PROPOSED RESIDENTIAL DEVEL
BIRCH CLOSE, EARL SHILTON
PLANNING REF 2009/067/04 (OUT)
SECONDREBEL LIMITED
PROPOSED LAYOUT AMEND OF FC:3242.A.

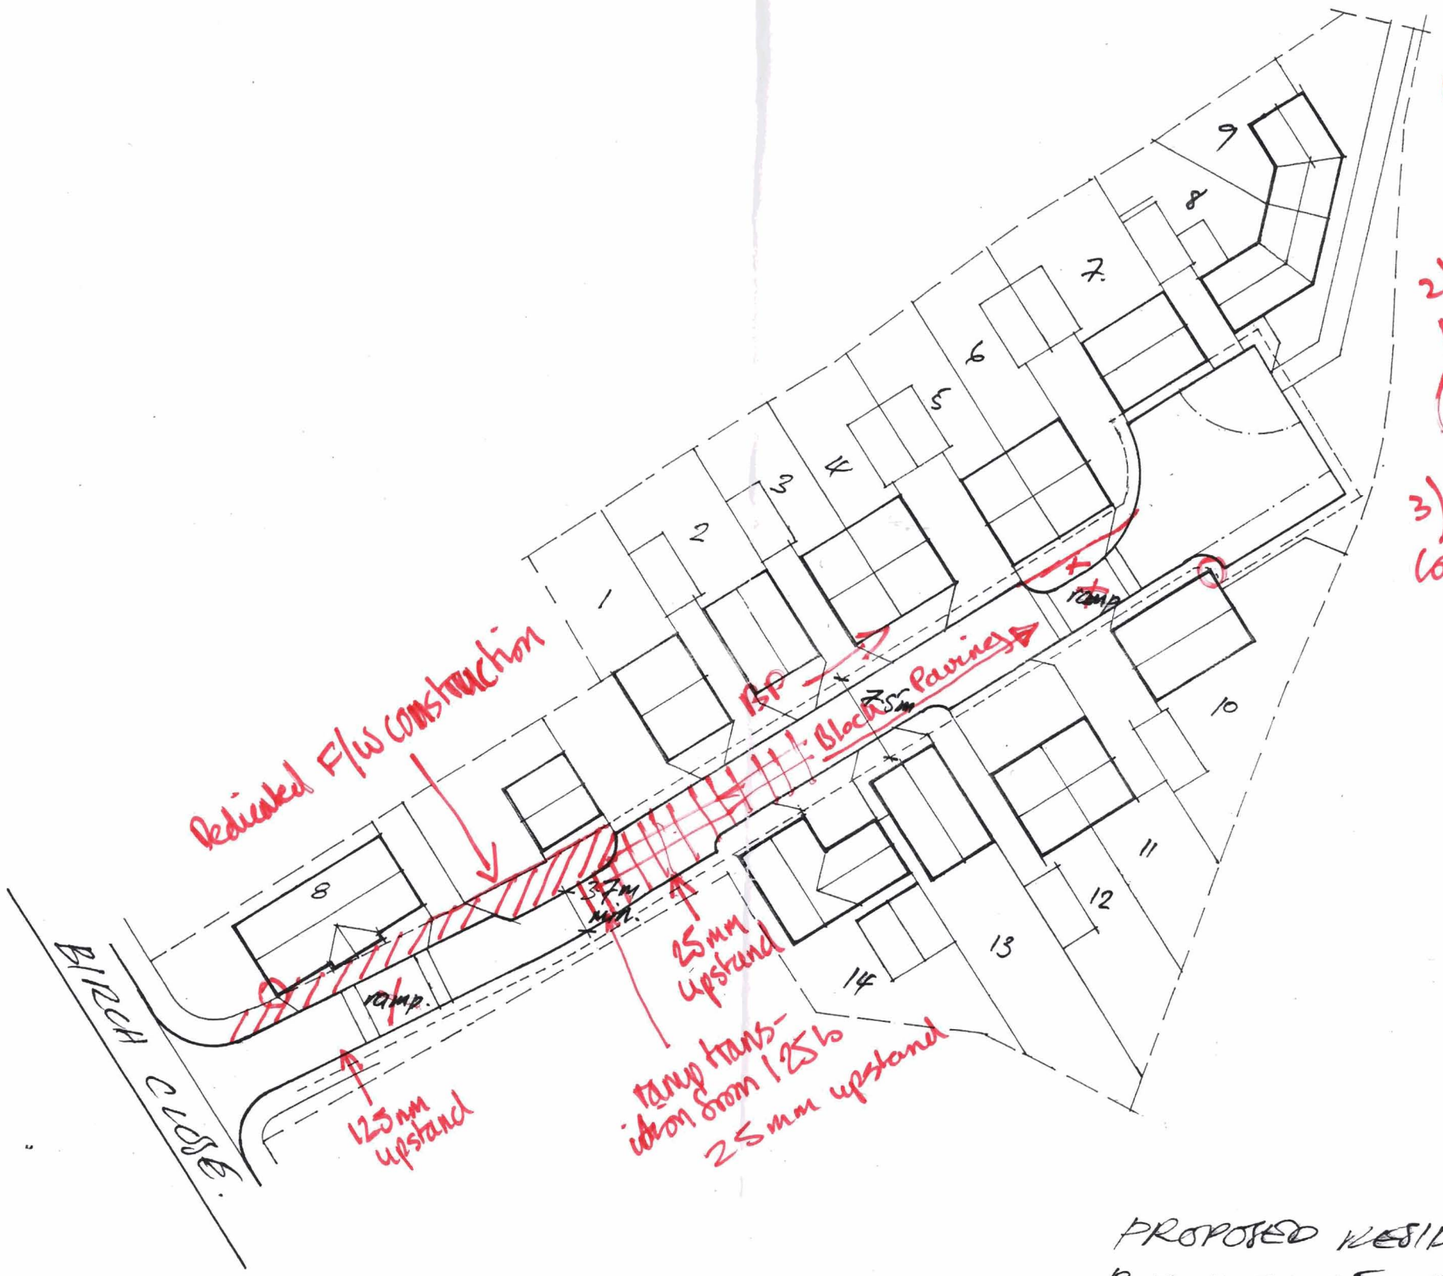
Notes — All buildings require 0.5m setback from highway boundary to accommodate down pipes / opening windows etc.

2) N.B Drainage solution to be identified asap. (presence S104 with water authority).

3) Detailed H/W specs to conform to HTD design guide
